MEMORANDUM

RE: ZP22-45, 44 Lakeside Avenue (also known as 32, 44 and 50 Lakeside Avenue)

File Number: ZP 22-45

Request: Install seasonal saunas and associated facilities on tandem parking spaces.

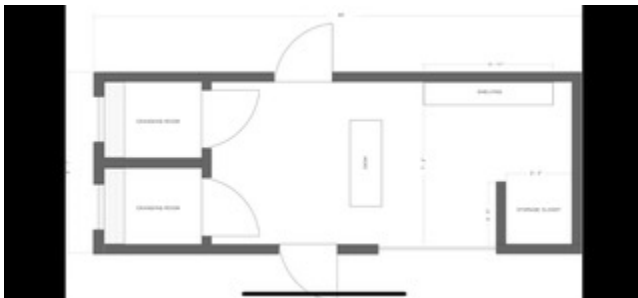
The *saunas* will run off propane tanks that are stored in a vented compartment under the benches. This arrangement must be acceptable to the building inspector. They will sit on blocks and can be removed in just a few hours. The saunas will have scissor gates installed to prevent break-ins when not in use.

Bathroom- Portable bathroom from 802 restrooms. It's winterized, has running water and 400 gallons of waste water capacity. 802 restrooms can service on demand. The above photo is a representation, however larger than is proposed. The Changing room plan is below.

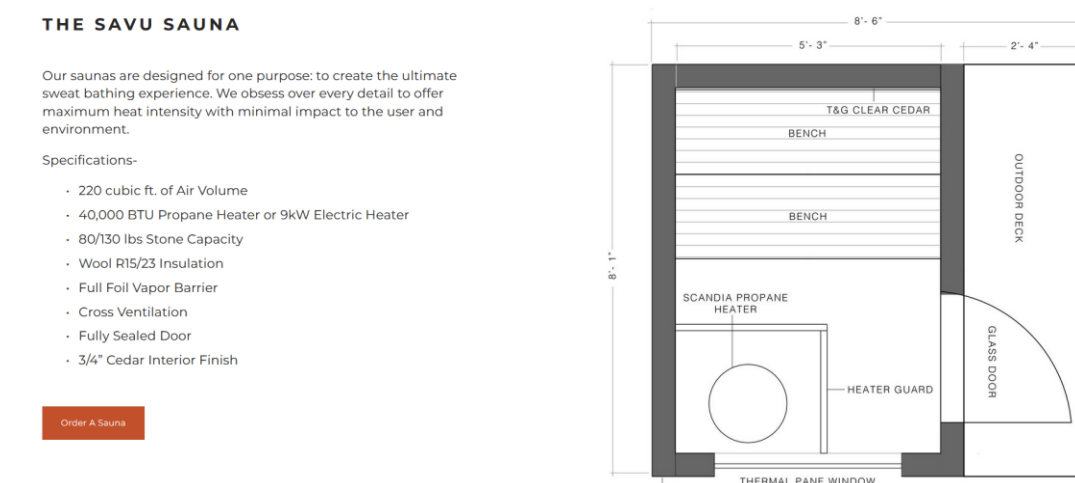
These are small, portable structures that will have a negligible impact on the overall site. From their website, the footprint looks like this:

Both the changing rooms and the office will be 8 x 12 boxes; the former divided in half to accommodate clients. **Affirmative finding.**
